**TOWN OF NEWBURGH
PLANNING BOARD
TECHNICAL REVIEW COMMENTS**

PROJECT: LANDS OF TARBEN, INC.
PROJECT NO.: 04-43
PROJECT LOCATION: SECTION 6, BLOCK 1, LOT 19 & 21 &
SECTION 17, BLOCK 2, LOT 110
REVIEW DATE: 1 AUGUST 2016
MEETING DATE: 4 AUGUST 2016
PROJECT REPRESENTATIVE: ZEN DESIGN

Tarben Re-submission Letter

Lands of Tarben Inc. - 15 Lot Subdivision

SURVEYOR ANTHONY D. VALDINA 	LANDS OF TARBEN INC. 15 LOT SUBDIVISION/LOT LINE CHANGE SURVEY PLAT SBL: 6-1-(19,21) & 17-2-110 TOWN OF NEWBURGH, ORANGE COUNTY, NY		
	DATE 3/1/04	SCALE 1" = 60'	SHEET NUMBER 22379-TAR 1 OF 11

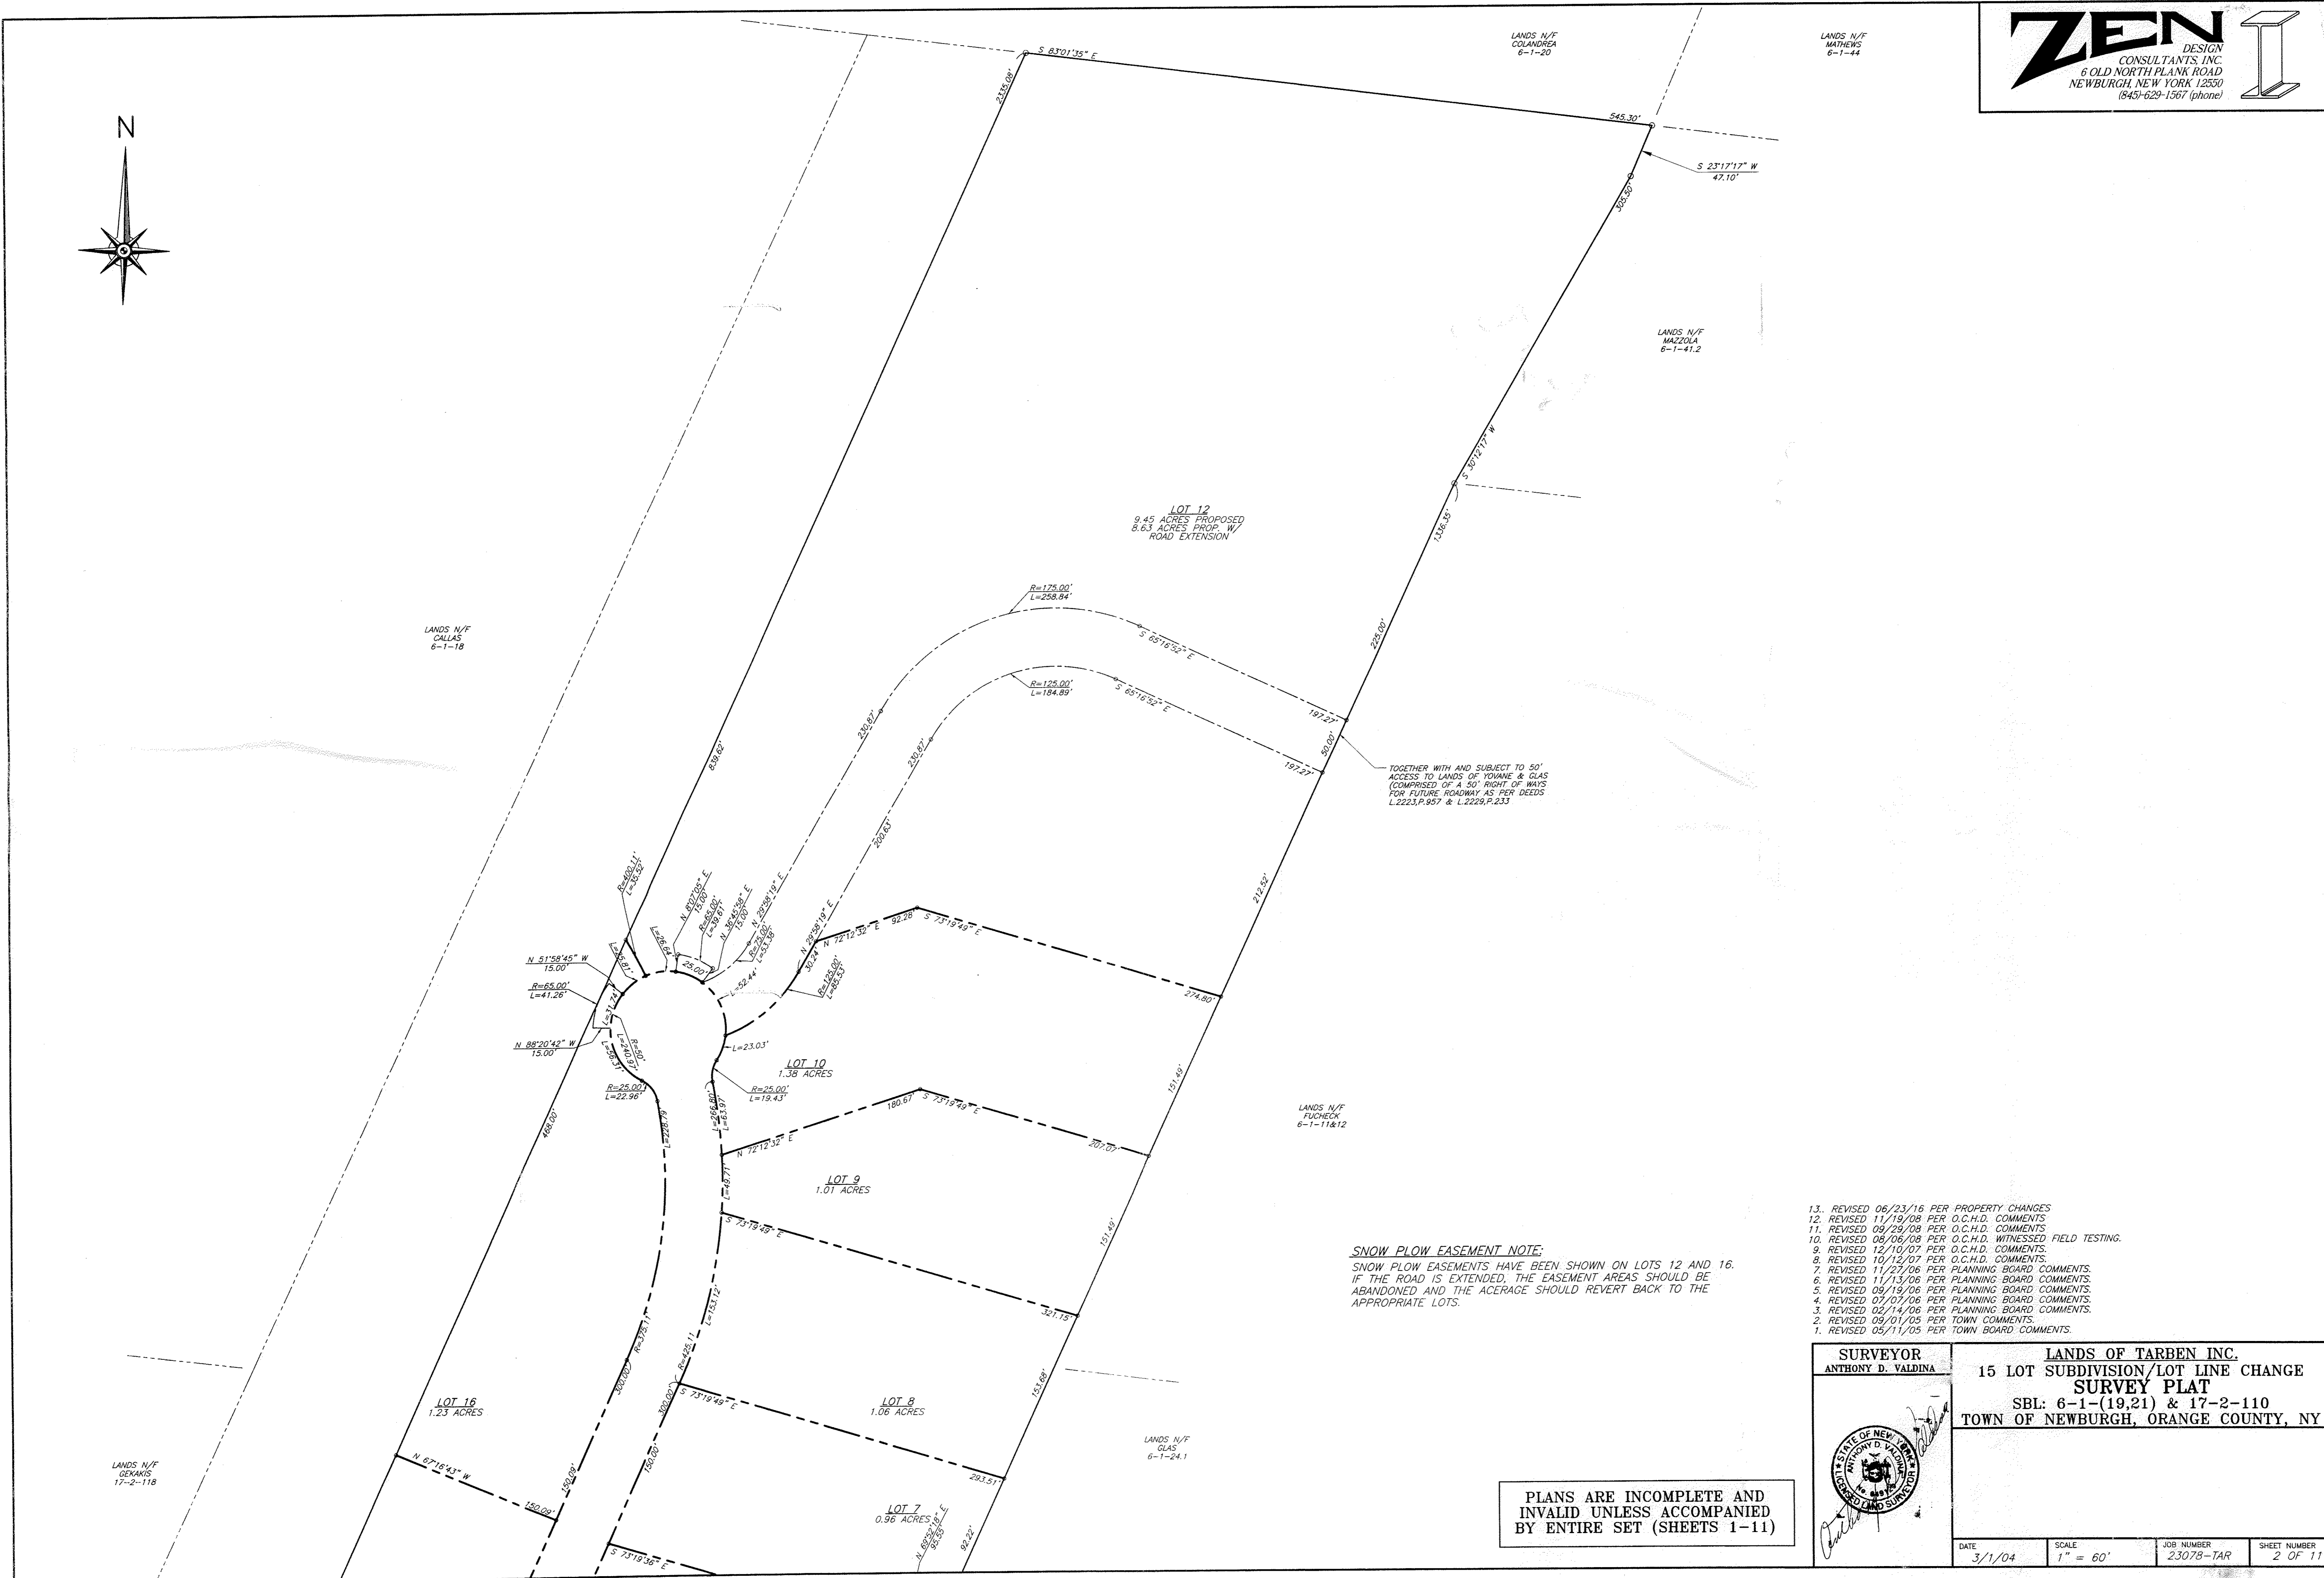
4. Mike Donnelly's comments regarding the proposed easement depicted on what is now lot 12, which if dedicated for roadway purposes would segment lot 12 should be received.

5. Lot 16 is depicted as a 1.23 acre parcel. The narrative identifies that lots 14, 15 & 16 were combined into 1 lot.
6. The Planning Board should evaluate the location of the cul de sac which terminates prior to the adjoining lots. The location of the cul-de-sac would prevent future expansions to adjoining lots as it is no longer connected to the adjoining lots based on lot revisions.

OUTLET STRUCTURE POND #1
 N.T.S.

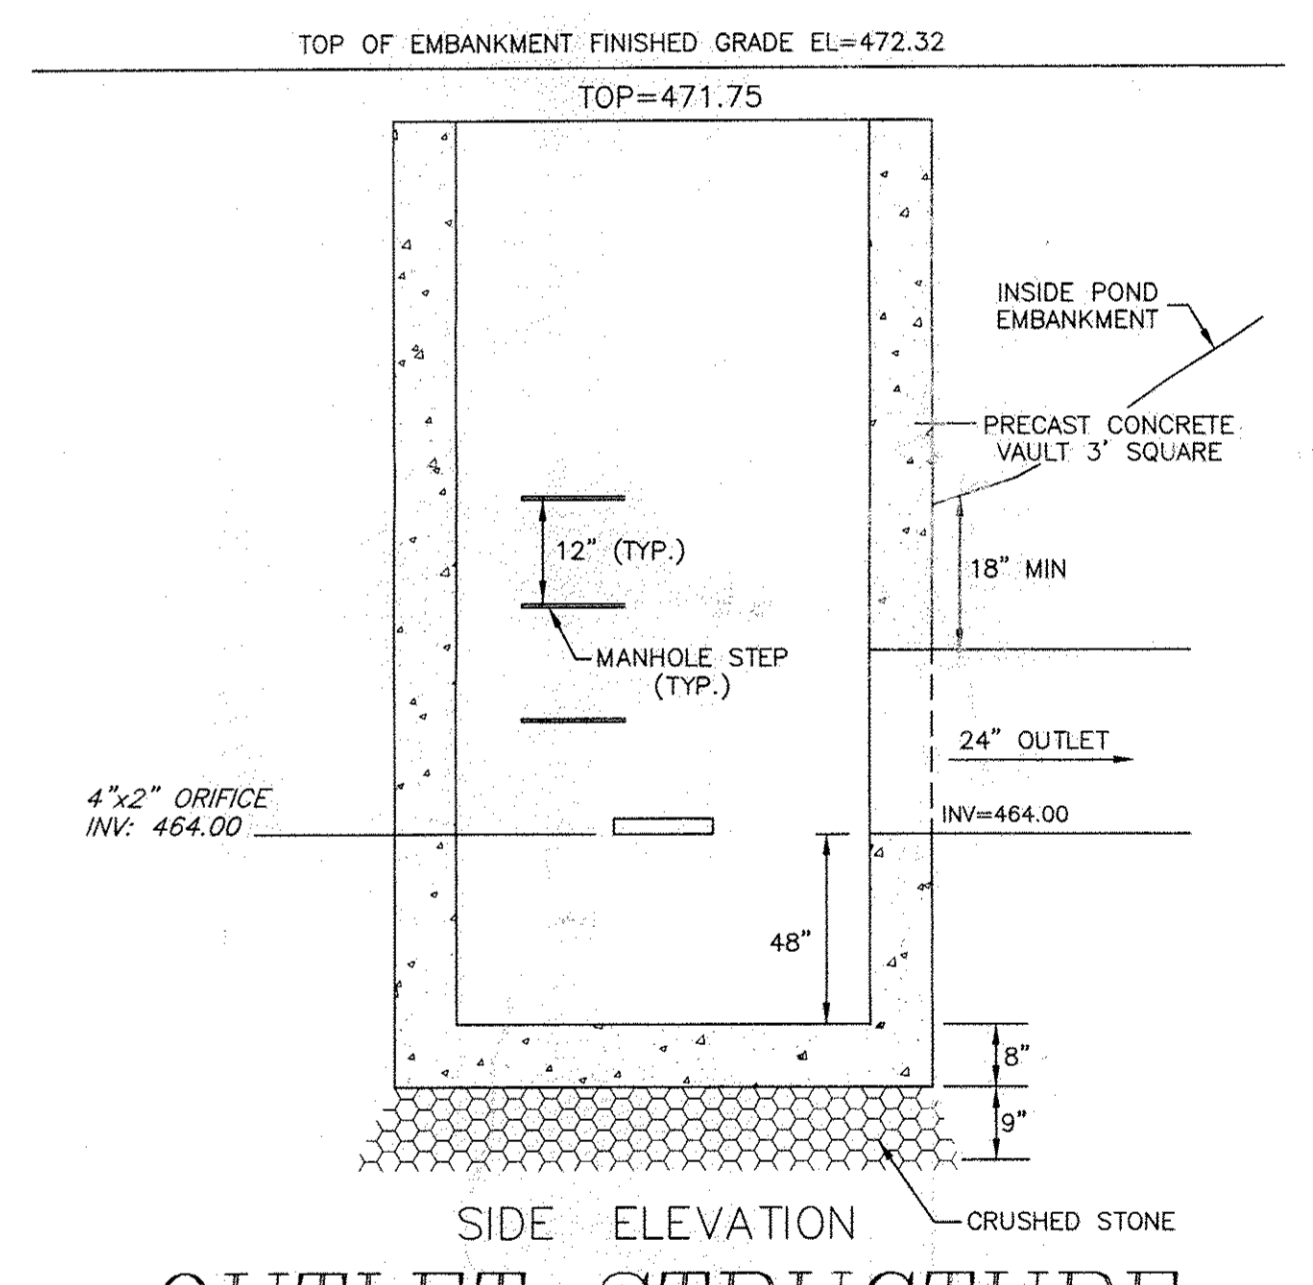
2. Stormwater Management pond has been revised. Revised Stormwater Management Report should be submitted modeling the revised pond.
3. Cross grading easements should be provided for grading of roadways and grading depicted across lot lines.
